CLIENT & PROJECT NIAGARA MOHAWK - NMP2		PAGE 1 OF 38
CALCULATION TITLE (Indicative of the Objective): VERIFICATION OF STRUCTURAL INTEGRITY OF THE MODIFIED MSIV ACTUATOR - SPEC. P303D		QA CATEGORY (✓) <input type="checkbox"/> I - NUCLEAR SAFETY RELATED <input checked="" type="checkbox"/> II <input type="checkbox"/> III <input type="checkbox"/> OTHER

STONE AND WEBSTER ENGINEERING CORPORATION
 ENGINEERING & DESIGN COORDINATION REPORT

PROJECT/CLIENT: NINE MILE POINT NUCLEAR STATION - UNIT 2 NIAGARA MOHAWK POWER CORPORATION

STONE AND WEBSTER ENGINEERING CORPORATION ENGINEERING & DESIGN COORDINATION REPORT		PAGE 1 OF 7 EDCR NO. M10030A JOB ORDER NO. 12177	
PROJECT/CLIENT NINE MILE POINT NUCLEAR STATION - UNIT 2 NIAGARA MOHAWK POWER CORPORATION			
P.O. NO. (S/W) P303D	REASON CODE(S) F, V	EQUIP. ID NO. (S/W) / SYB CODE (S/W) 2MSS & HXV 6A, B, C, D, 7A, B, C, D / 2MSS / 001-000	
REFERENCE DOCUMENTS EDCR M10030A		SUPPLIER (OR SUBSUPPLIER) NAME ENERGY PRODUCTS GROUP	
DESCRIPTION SUMMARY MID. PN2YPCMX118 TO MSIV ACTUATORS		REMARKS REVISE EDCR M10030A	
PROBLEM DESCRIPTION AREA 1 / REACTOR [PN2YPCMX118] THE FOLLOWING INTERFERENCES HAVE BEEN IDENTIFIED IN THE MSIV ACTUATOR MODIFICATIONS IDENTI

971
 13
 PAGE 2 OF 4
 E & OCR M10030A

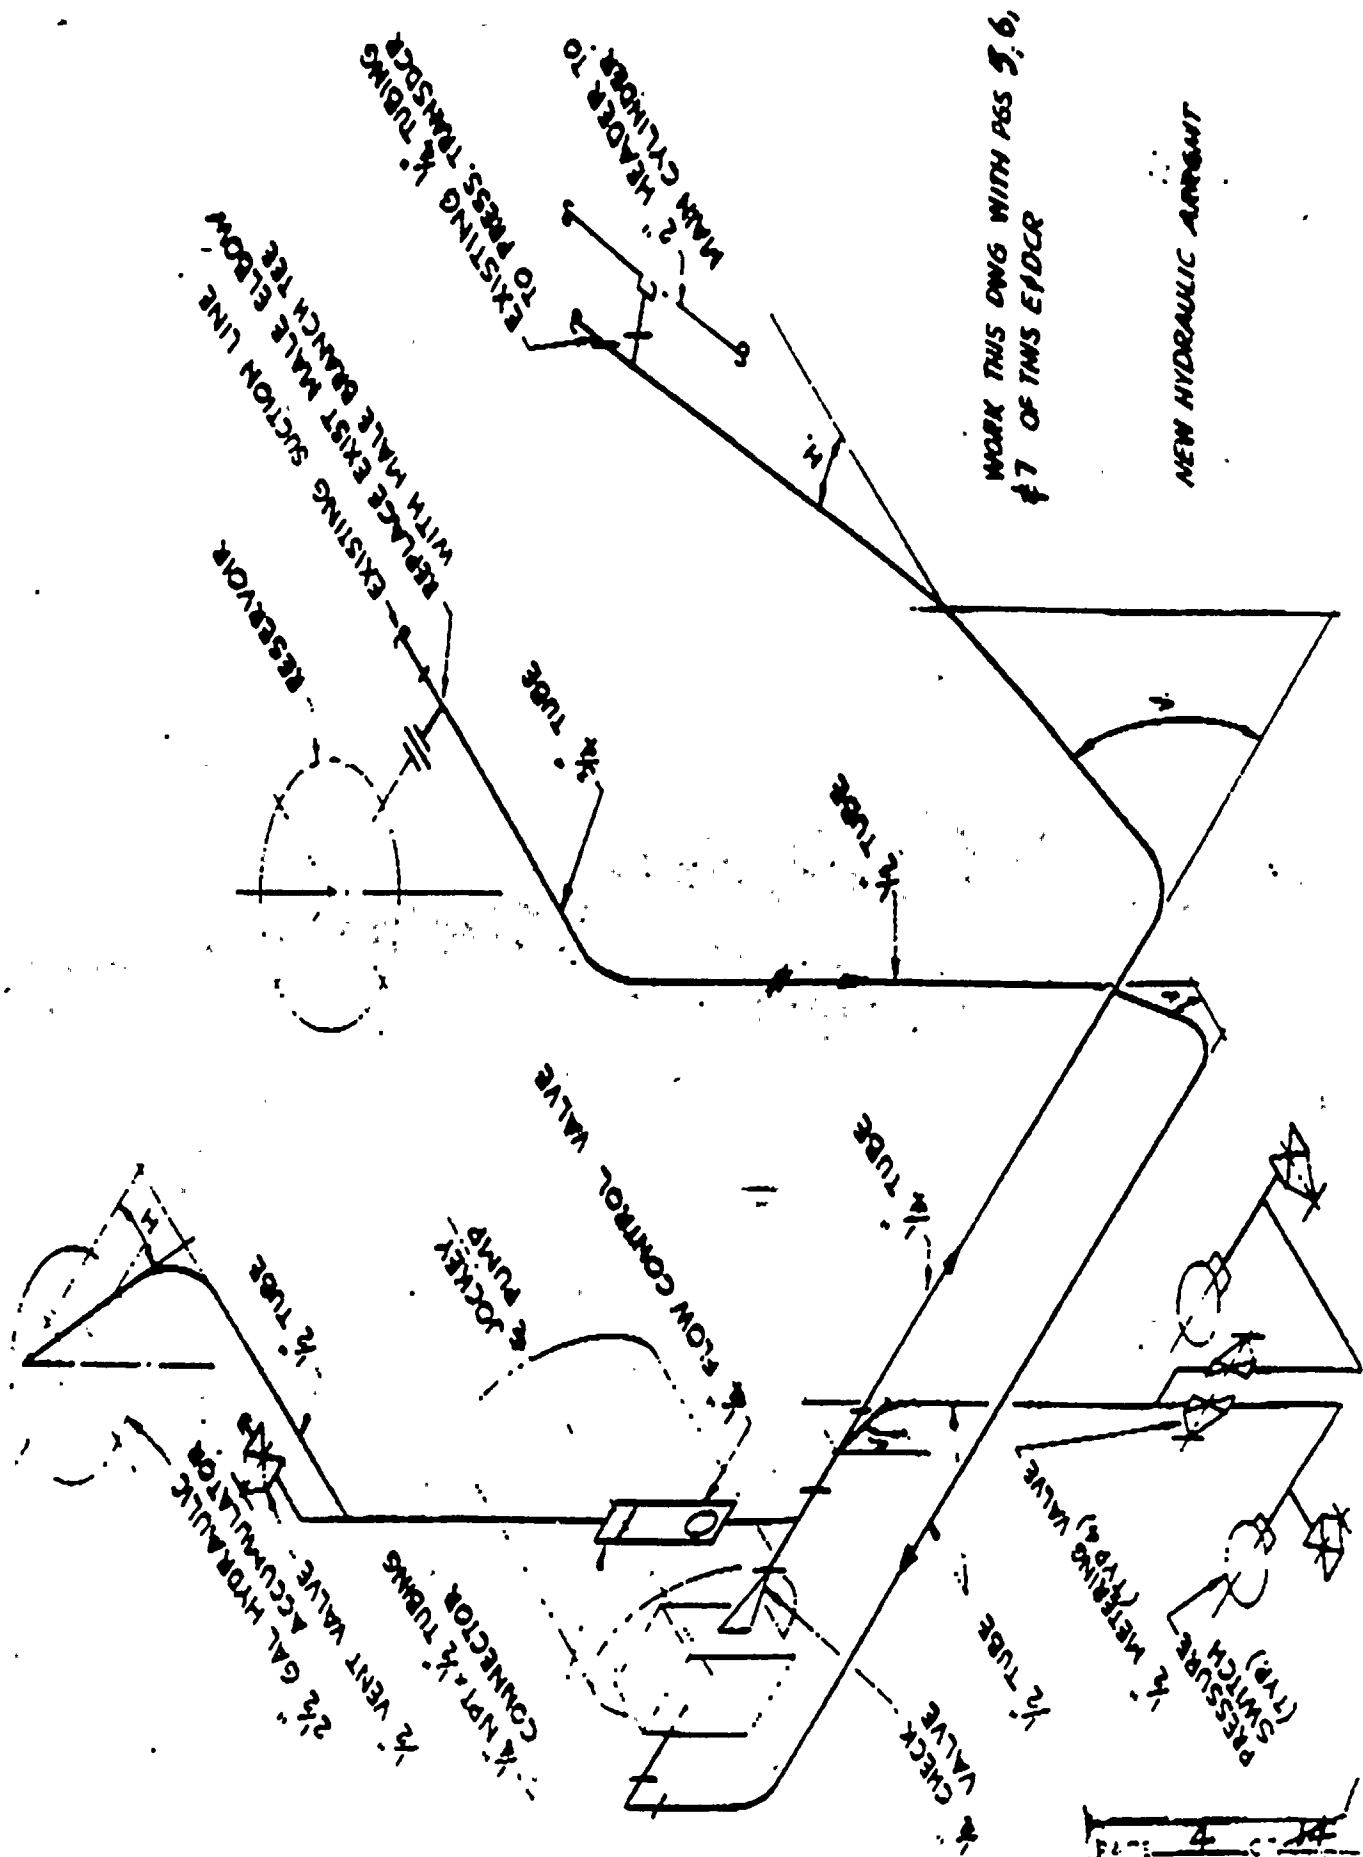
- 7. Material: Plate - Steel ASTM A36.
 Struc. shapes - Steel ASTM A36.
 "U" bolts - Steel A 36. *
 Bolts - Steel ASTM A307
 Nuts - Steel ASTM A307
- 8. Remove pivot door, blocking lever, blocking lever support bracket, trip solenoids and all associated hardware. Components to be tagged, boxed and stored.

- 11. Relief valve (RV) shall be set at 1500 psi.
- 12. An in service leak test shall be performed on the modified hydraulic return header in lieu of a hydrostatic test.

- 13. Prior to heat up, it shall be verified that the accumulator charge is 825 psi.
- 14. Pressure switches shall be set so that the jockey pump maintains a hydraulic system pressure of between 1100 psi and 1300 psi.

- 15. The flow control valve shall be so adjusted as to provide a flow rate of $1 \frac{1}{2}$ GPM from the accumulators to the hydraulic system.

EPDCR M10030B
Pg. 3 OF 7

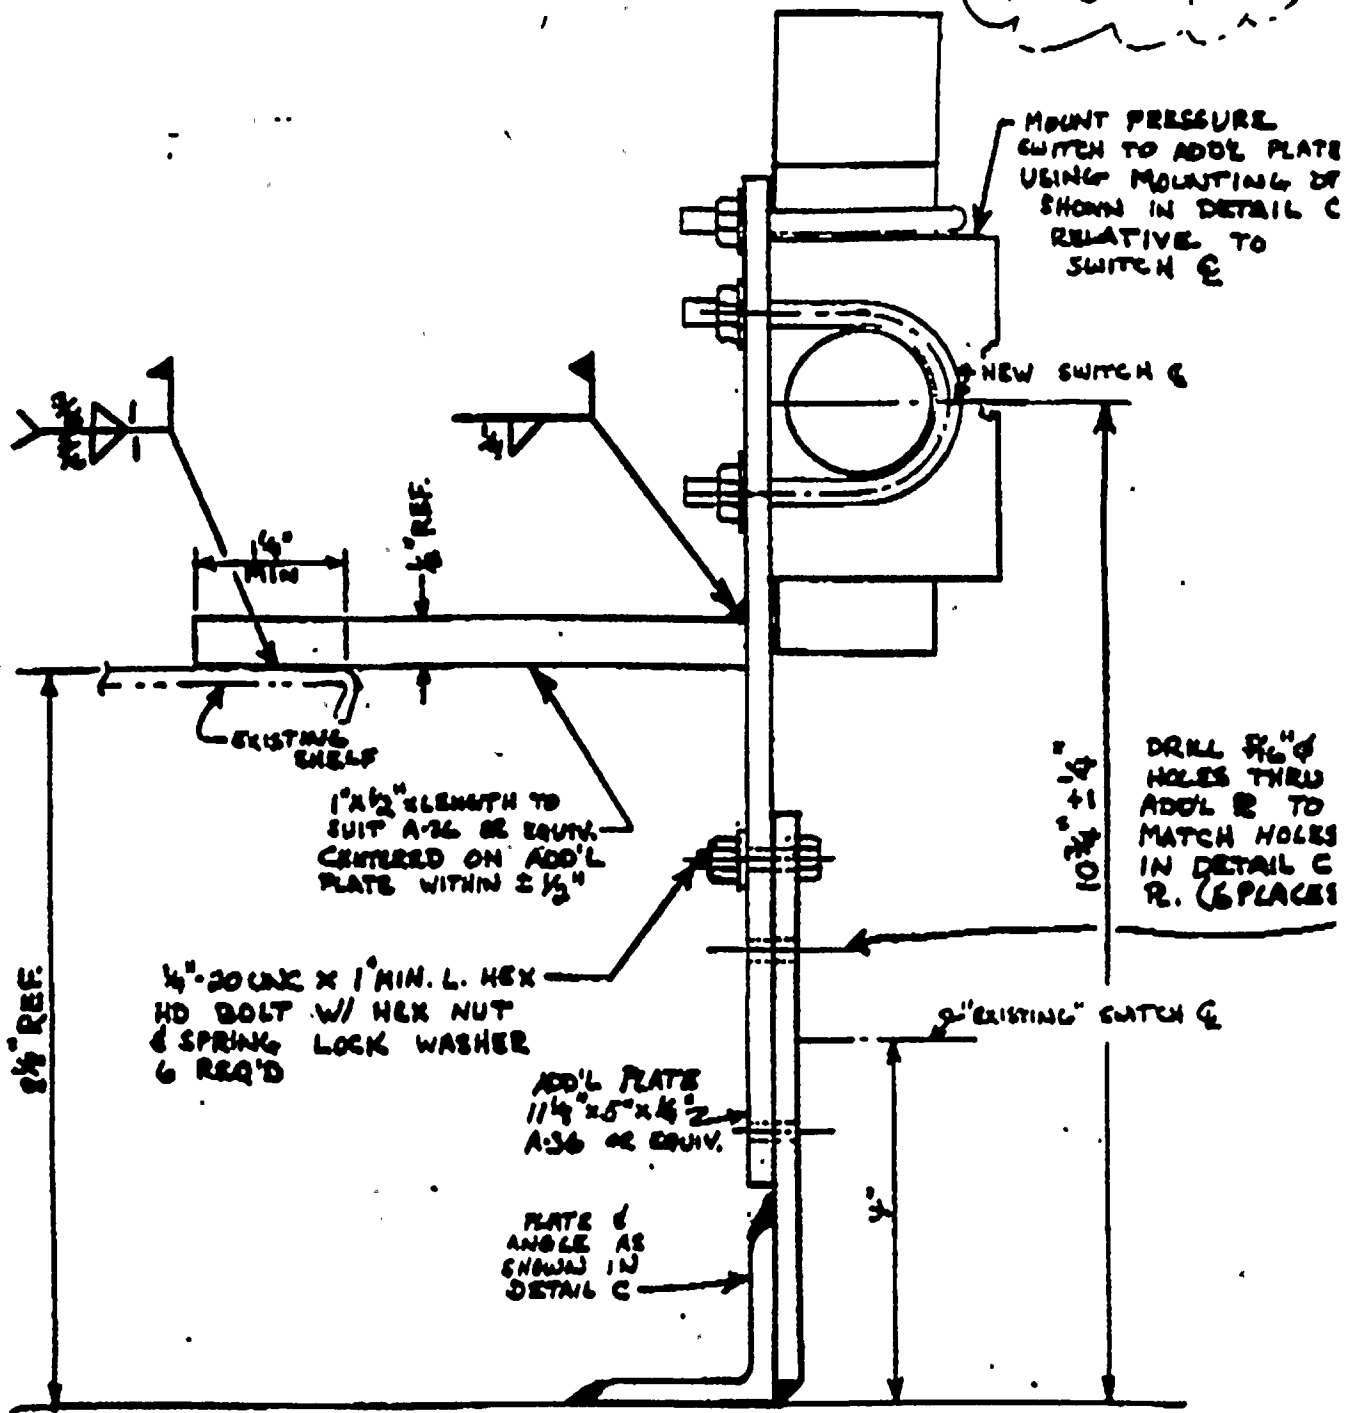
1. REVISE ACCUMULATOR MOUNTING BRACKET AS SHOWN ON PGS. 5 & 6 OF THE EDCR. 2. REVISE PRESSURE SWITCH MOUNTING BRACKET FOR THE IDENTIFIED SWITCH AS SHOWN ON PG. 3 OF THIS EDCR. 3. CHANNEL ATTACHED WELD DT. SHALL BE REVISED AS SHOWN ON PG. 4 OF THIS EDCR. 4. REVISE SHIM BLOCK DIMENSIONS & WELDING IN SECT. 5-5 AS SHOWN ON PG. 7 OF THIS EDCR.			
INTERDISCIPLINE CONCURRENCE DISCIPLINE NR		ENGR. DATE 10-25-86	
AFFECTED DOCUMENT NUMBERS 17-5360-180-398 5360-180-111 5360-180-191 P303D COB1A P301P P303D P301P		CLIENT APP. REQ'D DATE 10-25-86	
TYPE STATUS M C S N S N S N S N S N		RELATED ACTIVITIES B I, II	
ANSWERED BY R.T. Cooney		DATE 10-25-86	
RESR. LEAD ENGR. [Signature]		WORK RESP. SUB ITEM 01	
MATERIALS ENGR. [Signature]		WORK RESP. SUB ITEM 02	
EQUIP. SPEC. [Signature]		WORK COMPLETION NWR <input type="checkbox"/> DATE	
ENGR. OR EA [Signature]		INSP. REPORT NO./SIC 01	
PROJ. ENGR. [Signature]		FINAL WORK TRACKING CLOSURE DATE

EDDCR M10030 B
PG. 4 OF 7

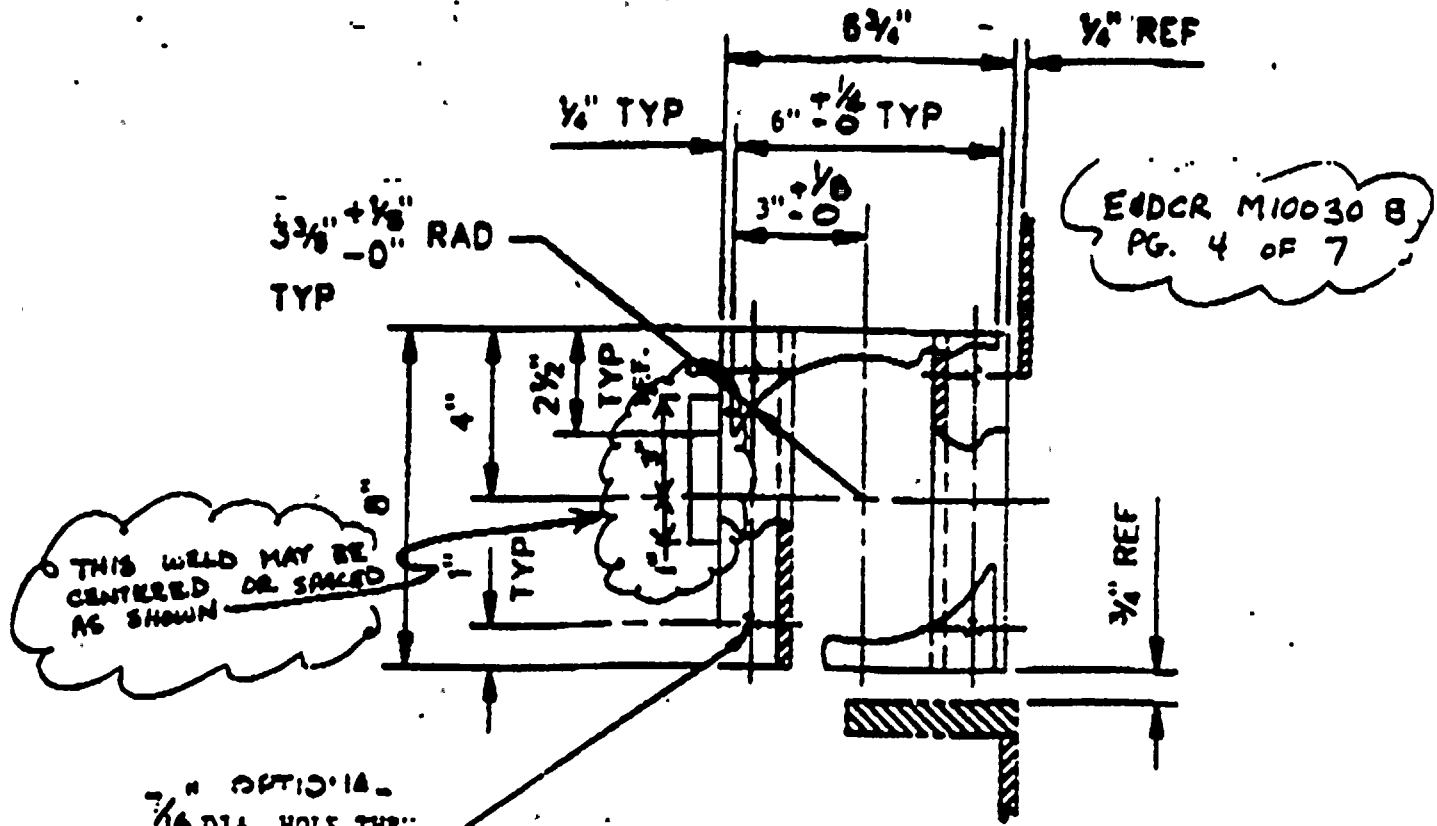
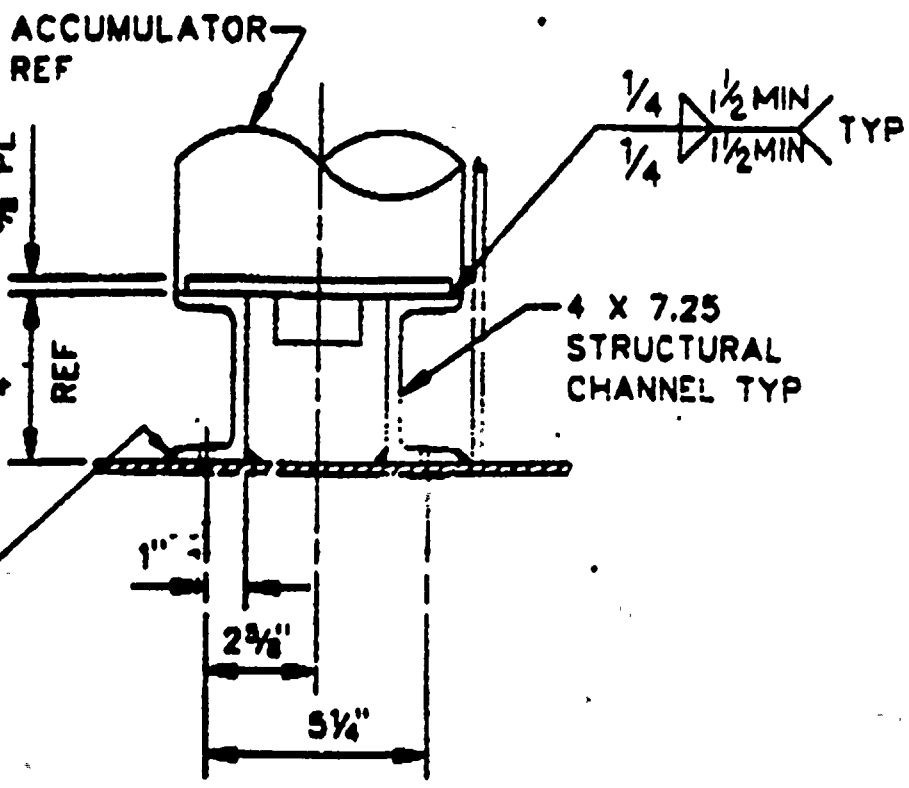
THIS WELD MAY BE
CENTERED OR SPACED
AS SHOWN

CENTER
WELDS
ON CHNL
UNLESS
OTHERWISE
NOTED

P. 22 6/7
EODCR M100308H
Pg. 6 of 7

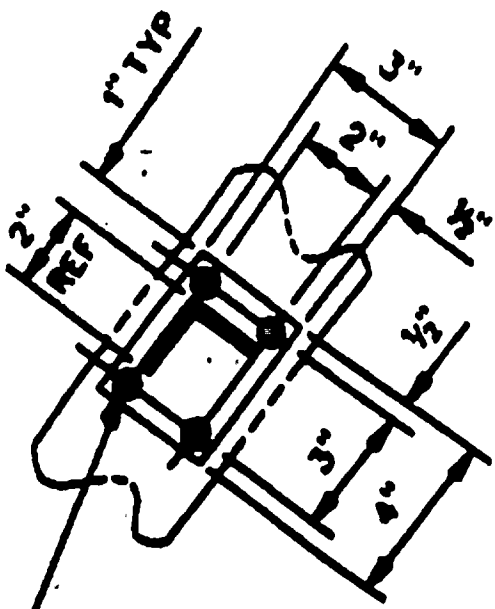
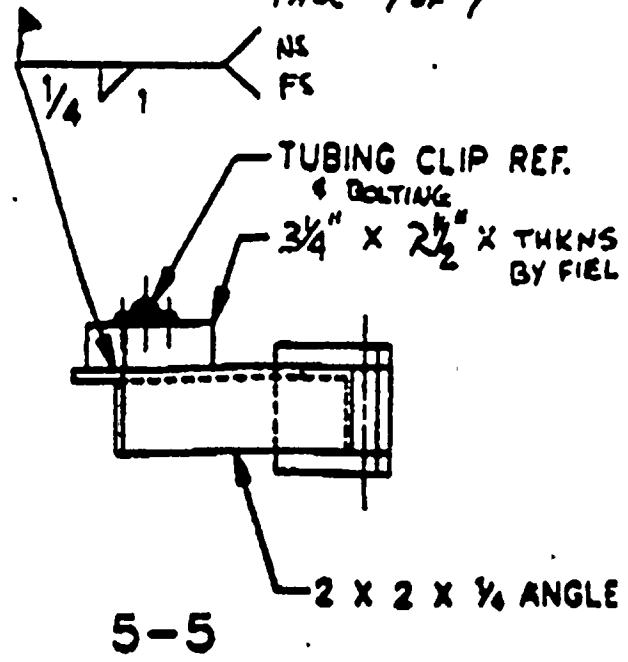
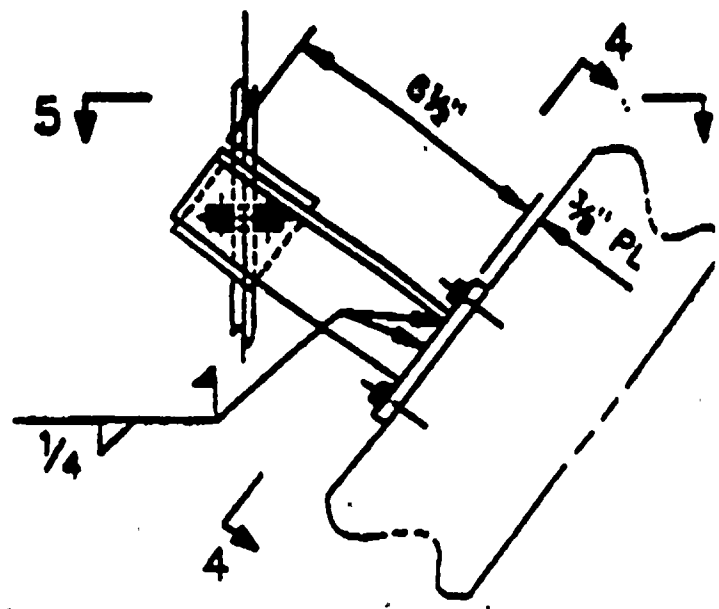
3/8" DIA HOLE THRU PLATE
 1/4"-20UNC TAP THRU STRL
 TUBING AT ASSEMBLY FOR
 1/4"-20UNC X 1" L HEX HD
 CAP SCREW WITH SPRING
 LOCK WASHER 4 EACH
 REQUIRED
